# MEMORANDUM

From:	Tina Cuss Ecology Officer		
Service	WBC Ecology	App No:	252520
Address:	Treetops, Fleet Hill, Finchampstead, Wokingham, RG40 4LE.		
Proposal:	Application for submission of details to comply with the following condition of planning consent 250957 dated 30/07/2025. Condition 3 relates to an ecological enhancement strategy.		
Type of Development:			
Site Visit Made:	No		
Summary Of Recommendations			
<input type="checkbox"/> No comment <input type="checkbox"/> No objection <input type="checkbox"/> No objection subject to conditions (and reasons) stated below <input checked="" type="checkbox"/> Request further information before determination as stated below <input type="checkbox"/> Objection due to the reason(s) stated below			
Comments On Proposal			
<p>I have read the revised Ecological Enhancement Plan report (Cherryfield Ecology, October 2025) and reviewed the Fleet Rise planning history including Ecological Appraisal (Cherryfield Ecology, November 2021), Bat Survey – Fleet Rise Annex (CA Ecology, 2015), and the Addendum Bat Survey Report (AA Environmental, Ref 183303 October 2018).</p> <p>Cherryfield Ecology's Ecological Enhancement Plan does not refer to Adde

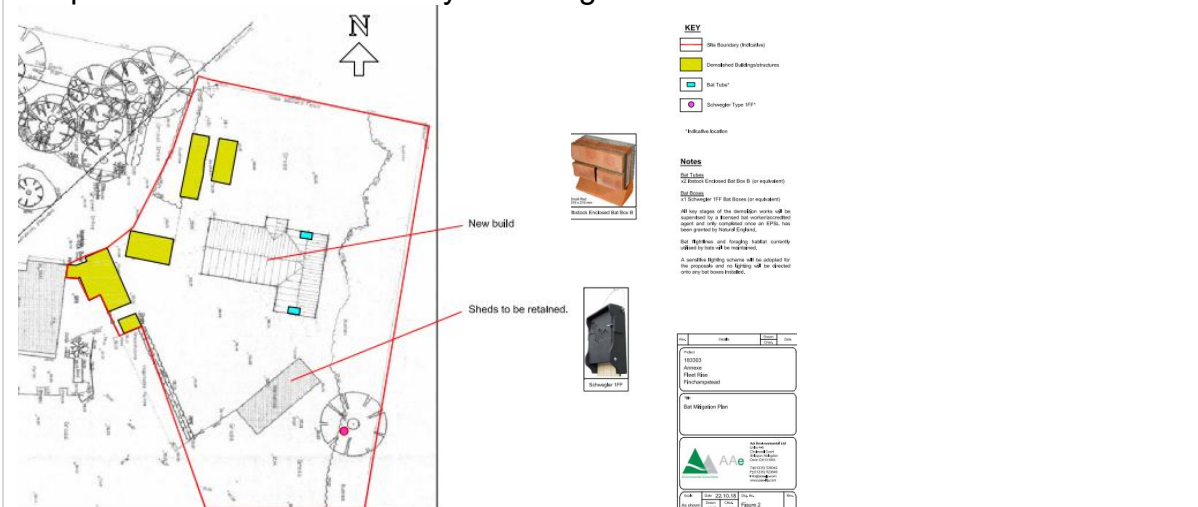
To ensure that roosting, foraging and commuting bats are not negatively impacted by light pollution and bats, and birds are not deterred from using the enhancements or retained habitat, I request that a revised report includes full details of all external lighting that has been installed. Lighting does not comply with the Ecologist proposals must be amended.

Lighting should be in line with the BCT lighting guidelines (Bat Conservation Trust, 2023)

As above, condition 3 does not request any information regarding detailed lighting proposals, therefore, a recommendation has been included to ensure that any lighting that is installed is in line with the bats and lighting guidelines.

Lighting will be in line with the new bats and lighting guidelines, thus protecting commuting and foraging routes.

This lighting should be of low level, be on downward defectors and, ideally, be on PIR sensors. Using LED directional lighting can also be a way of minimising the light spill affecting the habitat. No up-lighting should be used.
